Addendum No 001 Narrative

To Drawings and Specifications dated October 5, 2023

Walnut Grove Intermediate School – Science Classroom Modernization **West Covina Unified School District**

PBK Project No.: 202117
DSA A#: A# 03-123048
DSA File No.: 19-110

19 LAY IN DIFFUSER CONNECTION DETAIL
 NOT TO SCALE

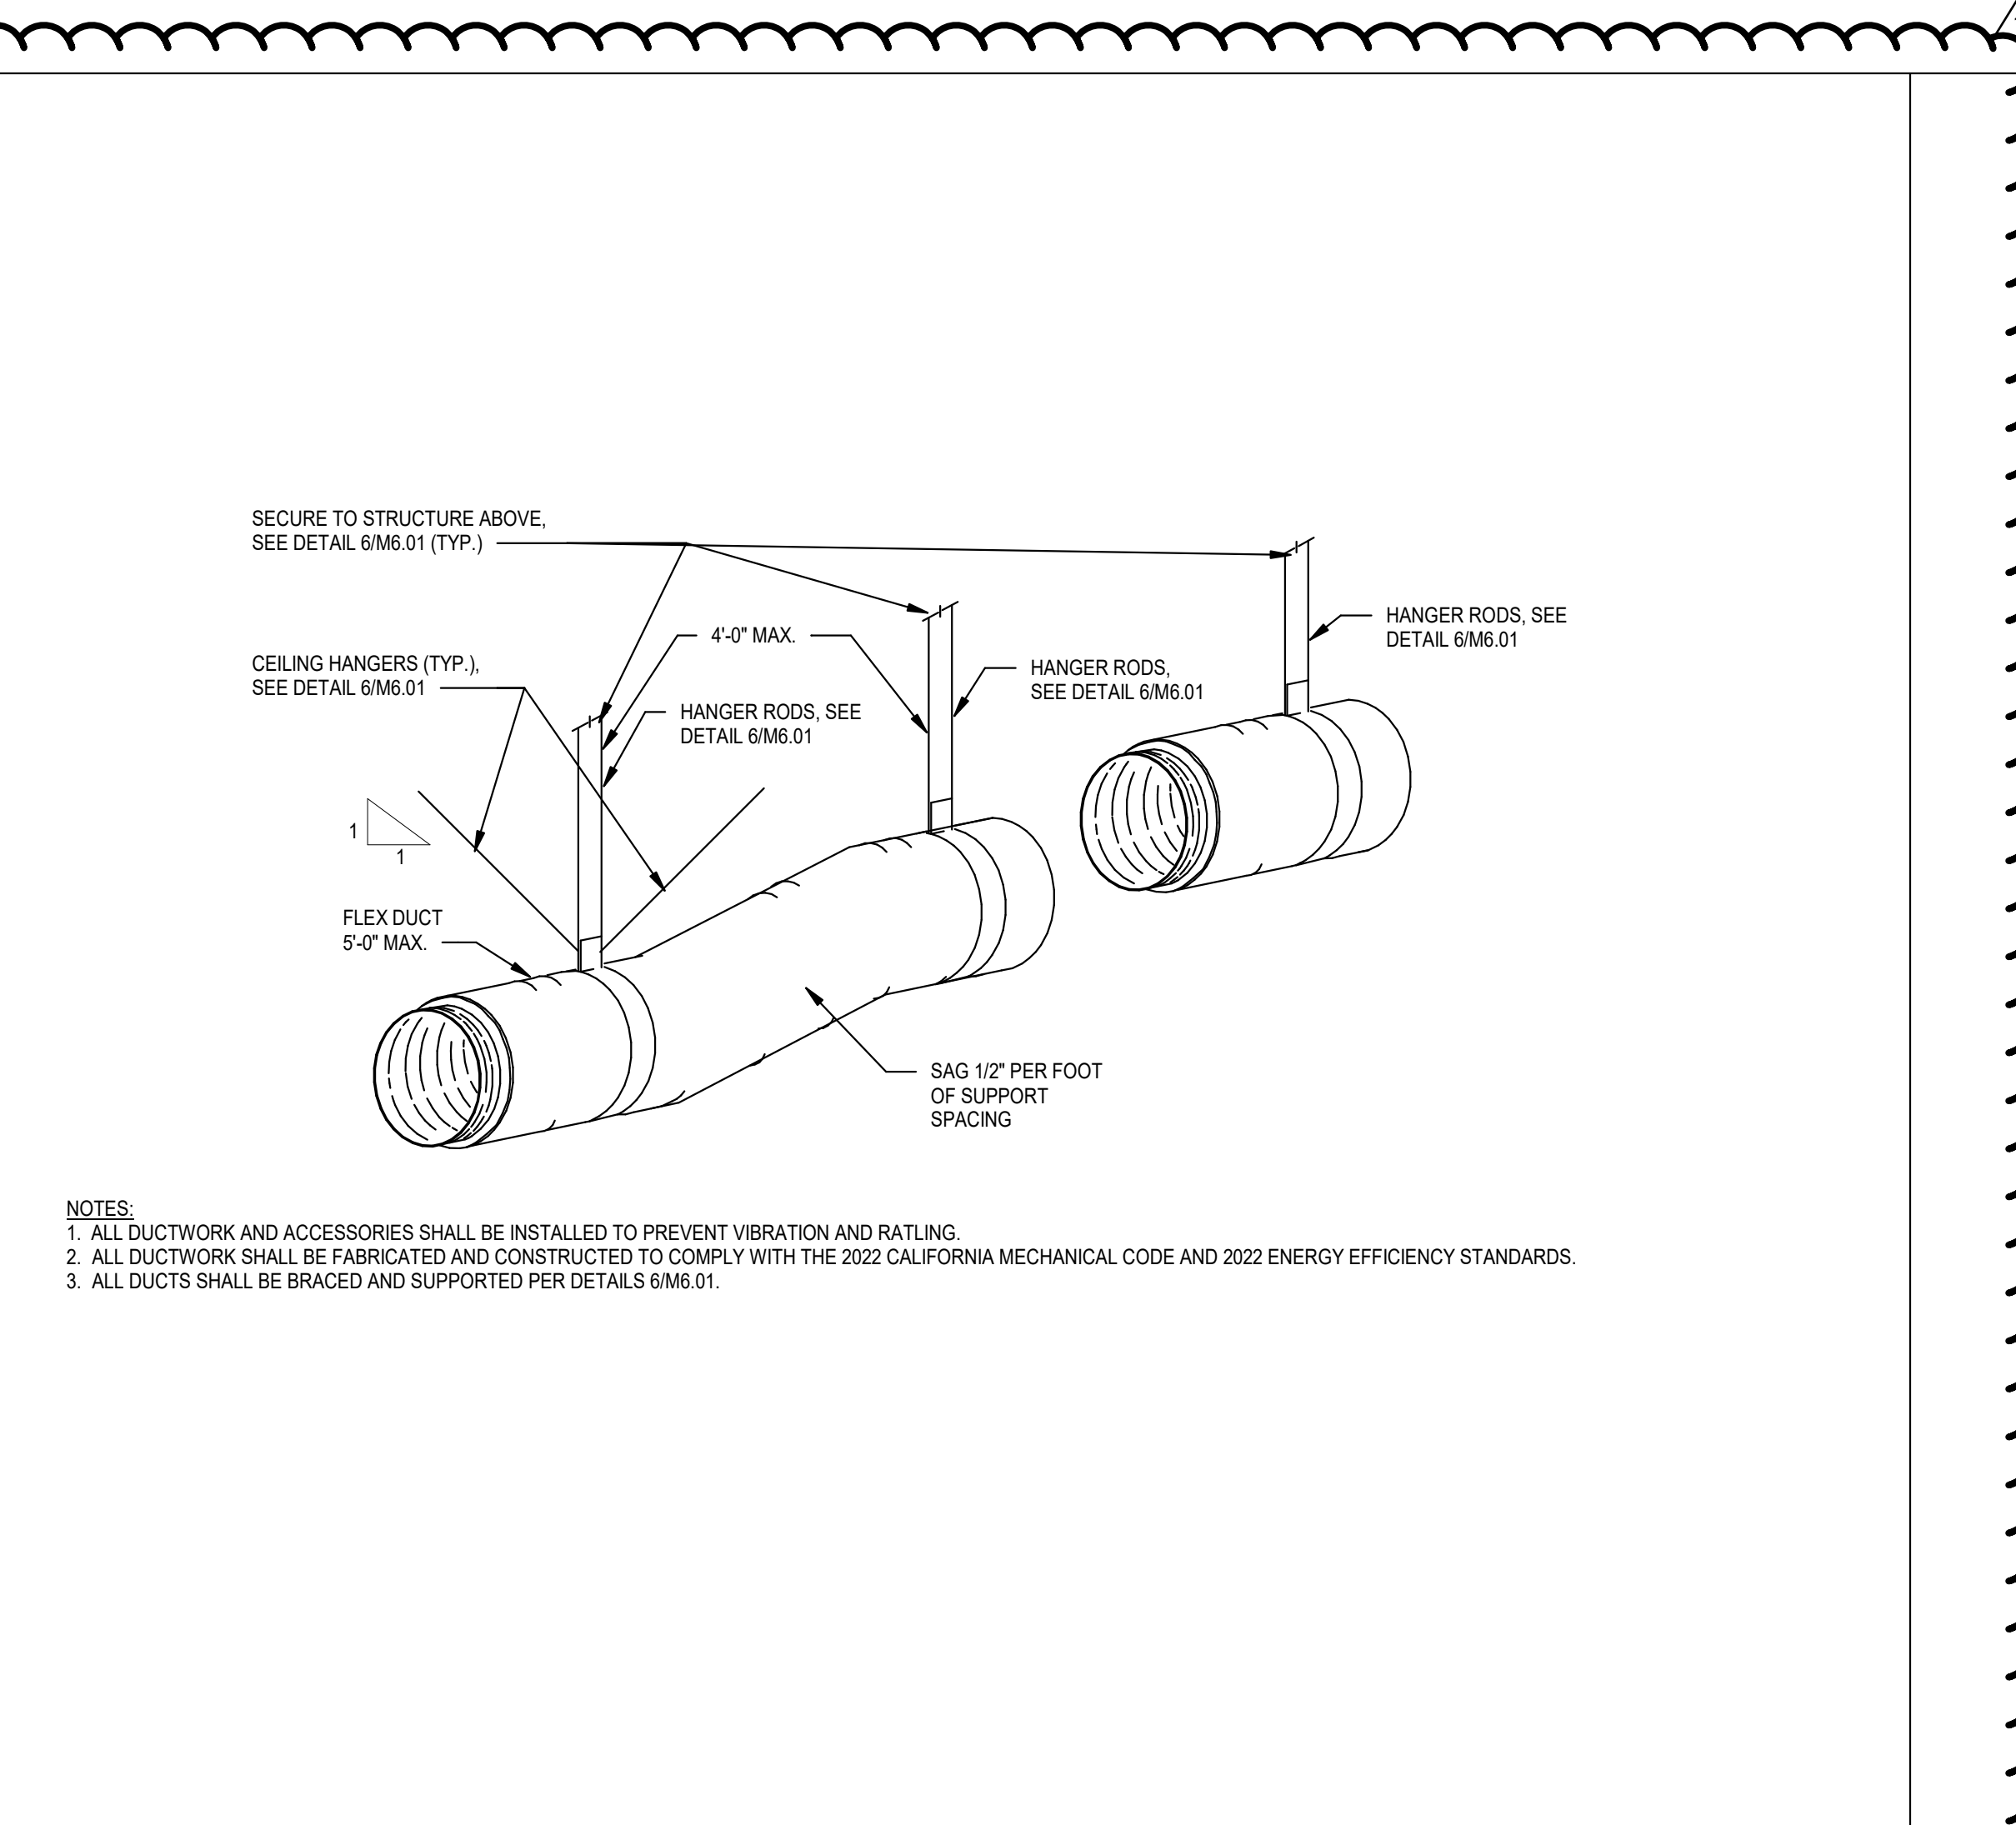
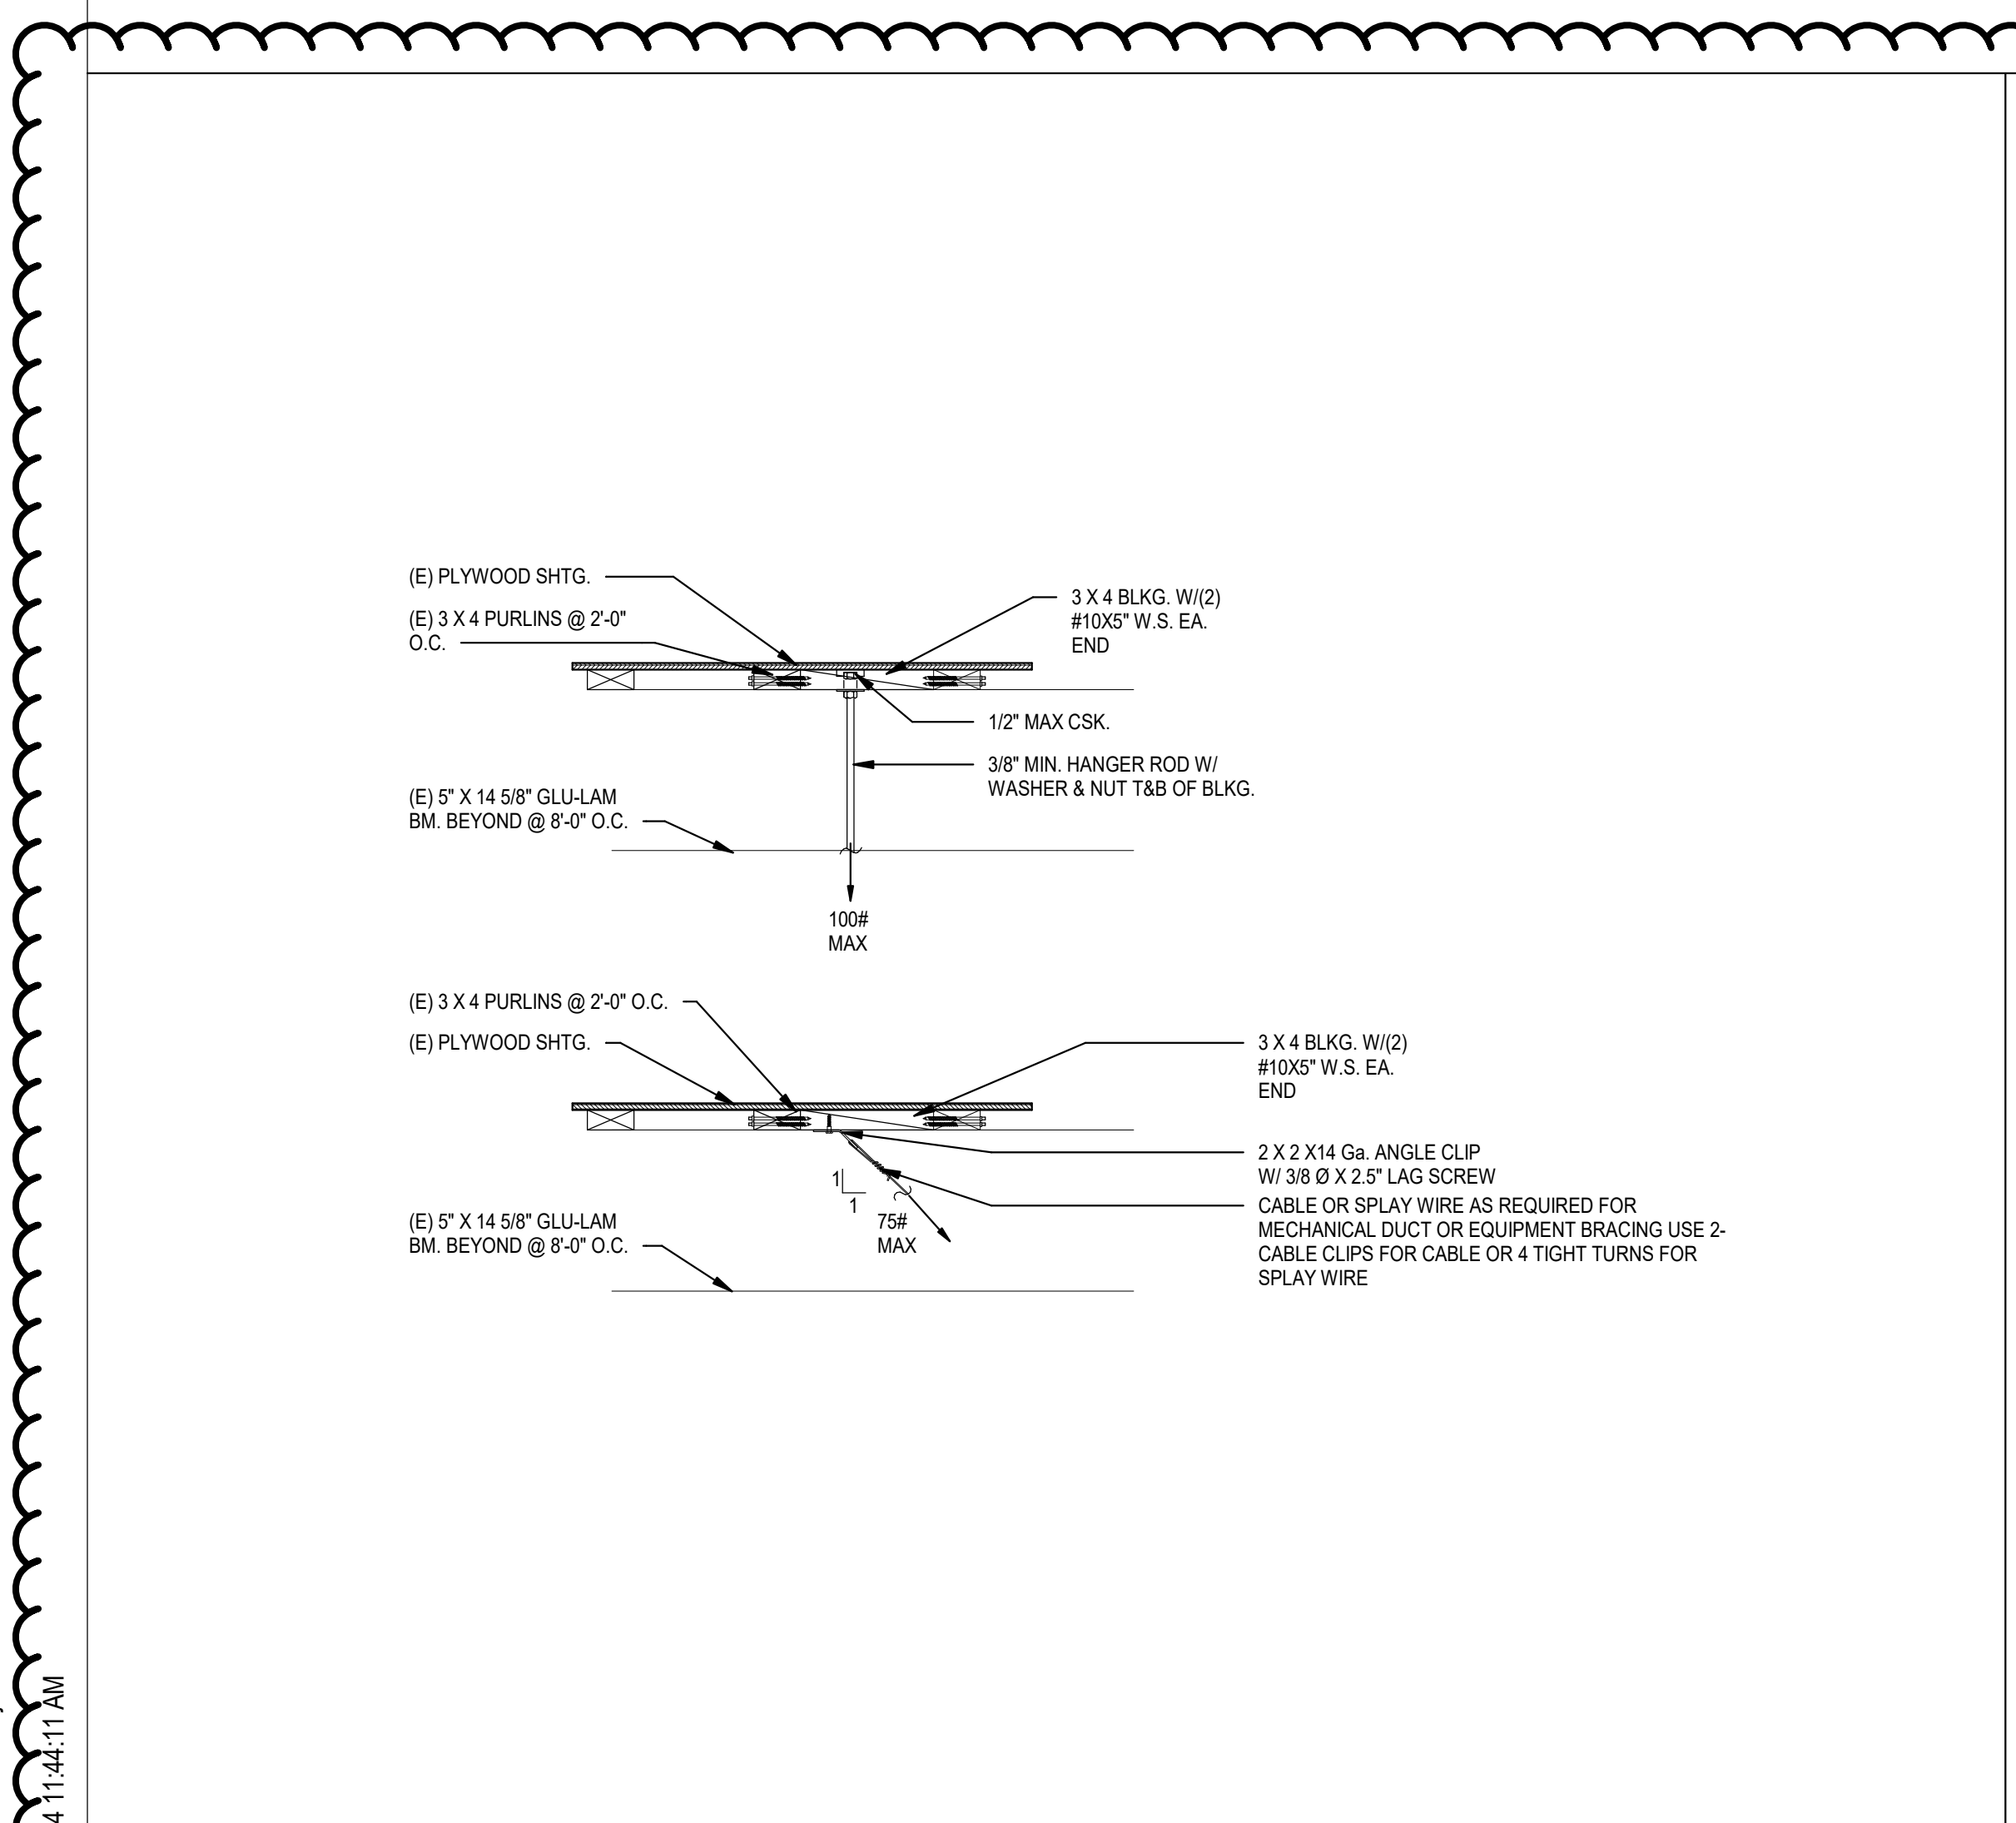
- A) Detail 19 – Modified note 1 and added note 2
- B) Added Detail 4 - Flexible Ductwork Hanger Detail
- C) Added Detail 6 - Typical Hanger Support Detail.
